NNI protection LACP alternative

Zehavit Alon

August 2010

NNI protection using LACP

Requirement 1

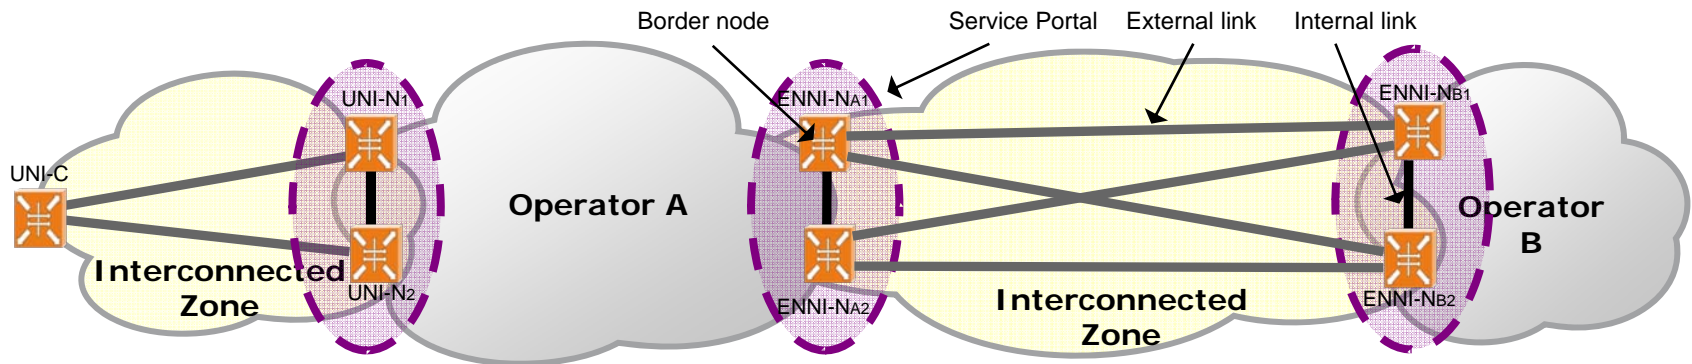
- All elements participating in the mechanism must be standardized, including the protocol running over the internal links (between border nodes in a single portal) as it is unreasonable to mandate that a portal will consist of border nodes from a single vendor

- In the proposed mechanism, the means by which the border nodes communicate and overcome failures are not defined as it is assumed that all border nodes in a specific network are from a single vendor

Requirement 2

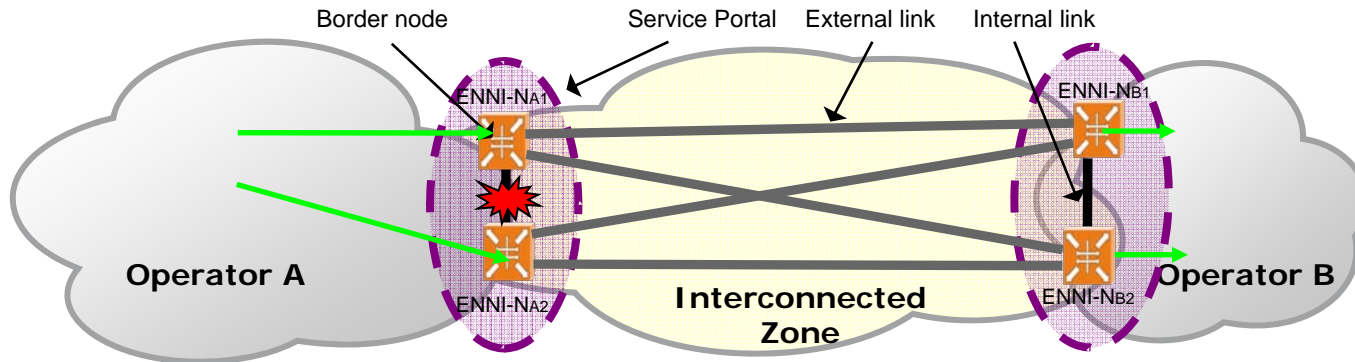
- The mechanism must provide a standard mean to guarantee that traffic will be received only once by a network

- In the proposed mechanism it is assumed that each network sends a packet only once. This functionality is not standardized and not guaranteed. If one network sends packets more than once (from more than one border node), the attached network will receive the same packet more than once.
- In the case where the connectivity between the border nodes is lost, packets may be sent to the attached network by more than one border node until the brain dead situation is identified and handled.

Requirement 3

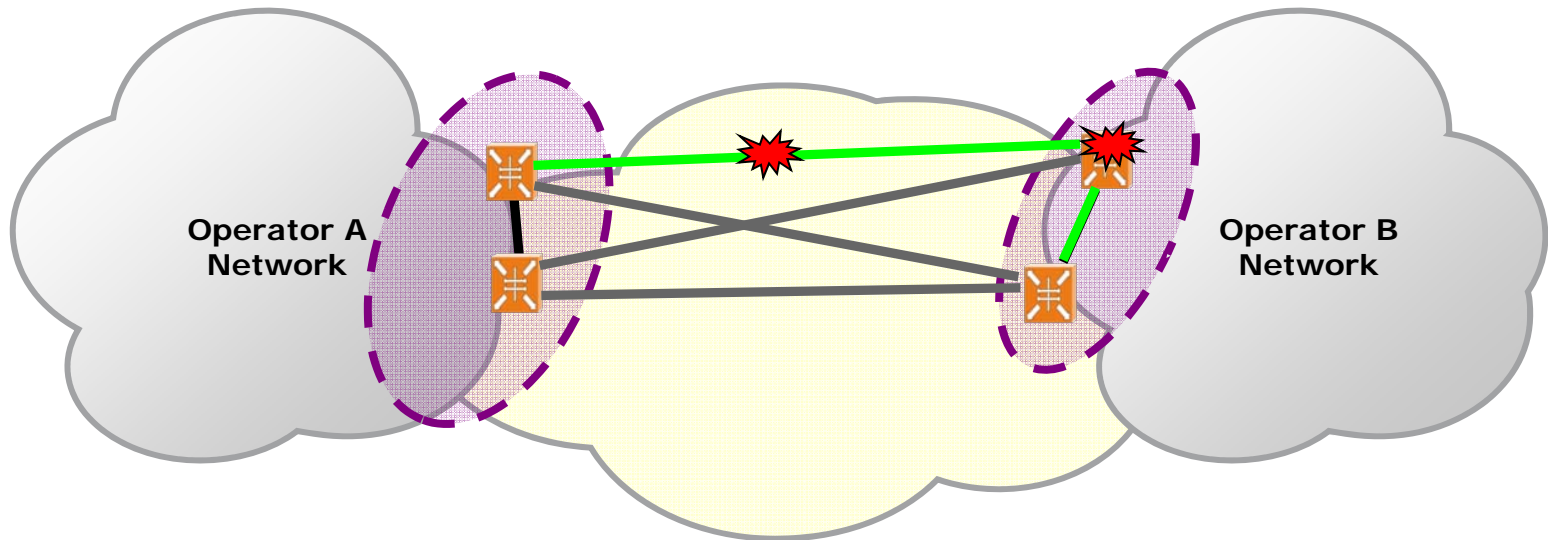
- The mechanism must function without internal links.

- Internal links are mainly used for data transfer when the service gateway can be preserved.
- The service gateway preservation is not mandatory as there are cases when such preservation is unachievable (node failure)
- Overcoming brain dead situations by shutting down a node will interfere with other traffic the border node handles, which is not influenced by the brain dead situation.
